UNITED STATES PATENT AND TRADEMARK OFFICE

APPLICATION NO.	FILING DATE	FIRST NAMED INVENTOR	ATTORNEY DOCKET NO.	CONFIRMATION NO.	
	10/722,938	10/722,938 11/26/2003 Lars		03370-P0061A	9635	
	24126 75	590 08/15/2005		EXAM	EXAMINER	
		TEWARD JOHNSTO	N & REENS, LLC	WILLIAMS, THOMAS J		
	986 BEDFORD STREET STAMFORD, CT 06905-5619			ART UNIT	PAPER NUMBER	
			3683

Application No.	Applicant(s)			
Office Assign Comments	10/722,938	SEVERINSSON, LARS			
Office Action Summary	Examiner	Art Unit			
	Thomas J. Williams	3683			
The MAILING DATE of this communication ap Period for Reply	pears on the cover sheet with the) correspondence address			
A SHORTENED STATUTORY PERIOD FOR REPL THE MAILING DATE OF THIS COMMUNICATION. - Extensions of time may be available under the provisions of 37 CFR 1. after SIX (6) MONTHS from the mailing date of this communication. - If the period for reply specified above is less than thirty (30) days, a rep - If NO period for reply is specified above, the maximum statutory period - Failure to reply within the set or extended period for reply will, by statut Any reply received by the Office later than three months after the mailine earned patent term adjustment. See 37

Replacement Sheet
Appln. No. 10/722,938
A Device in a Vehicle Brake Arrangement Lars Severinsson SSJR File 3370-P0061A

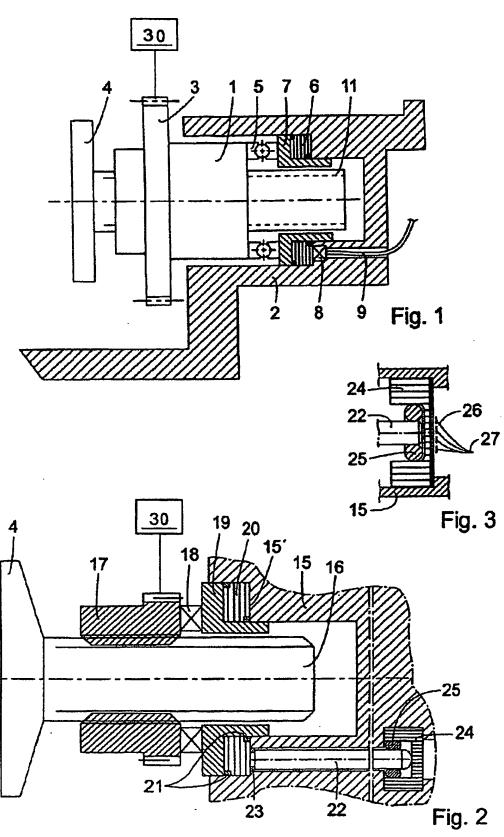
2. The drawings were received on June 27, 2005. These drawings are approved.
